Our Case Number: ACP-323849-25

Formal Observation

Re: Proposed Development — Cleeves Riverside Quarter / Cleeves Riverside Campus

Applicant: Limerick Twenty Thirty DAC

Fig 3. Surface water Dec 5th 2025 after a heavy shower.

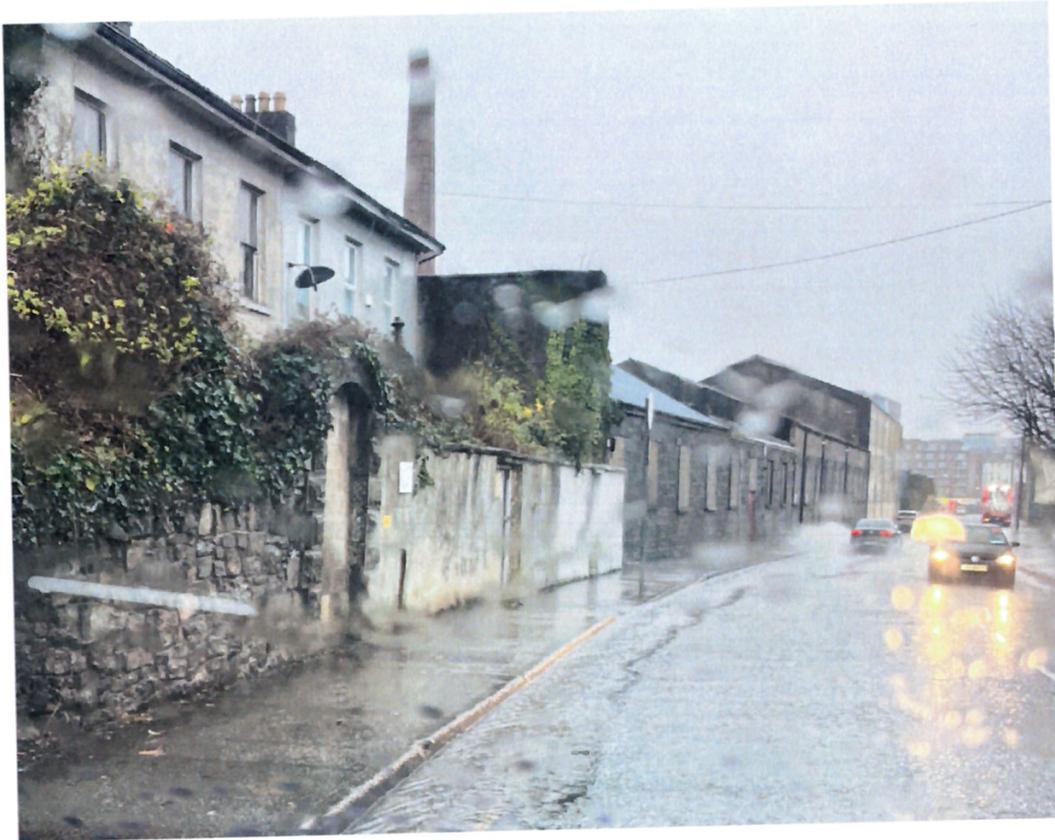
- Water quality:
 - Due to the sensitivity of the adjacent SAC and SPA, water quality results need to be an agreed frequency. Stating that this is a minimum monthly monitoring of groundwater is grossly insufficient and negligent allowing for significant damage to be done to the local SAC and SPA's.

- Full remediation of contaminated materials prior to construction, with independent verification of soil treatment and disposal. Without such safeguards, the risk of contamination migrating into the Shannon or impacting nearby residential areas is significant.

- Due to direct connection of the reservoir to westfields, monitoring to be done at the westfield site also.
 - Surface water run off not addressed in line with real impacts of climate change, i.e. not only on % increase in rainfall but also an increase in the intensity of rain (Fig 3.) indicating a need for greater monitoring and an increased amount of nature based solution for water absorption. The Hydrology report stated that when complete the site will only reduce surface water run off by 2 % for a new development is not sufficient or showing any creative use of Green/ blue infrastructure.

Portions of the site are at elevated flood risk, particularly in proximity to the river corridor and historic drainage basins. The applicant's Flood Risk Assessment acknowledges that the long-term safety of the site is contingent on the delivery of the Limerick City & Environs Flood Relief Scheme, which remains at design stage and has not yet been implemented. Reliance on future flood works that are outside the applicant's control represents a fundamental weakness. Without these measures, safe access and egress during extreme flood events cannot be guaranteed, and the proposed residential and student accommodation would be exposed to unacceptable risk.

The provided Flood Risk Assessment (FRA) fails to:

- incorporate up-to-date OPW data
- assess cumulative flood impacts
- address climate change scenarios
- examine displacement effects
- map surface-water pathways affecting neighbouring streets

No occupation of residential or student units should be permitted until the Flood Relief Scheme is operational and certified, protecting both future residents and the integrity of the planning system
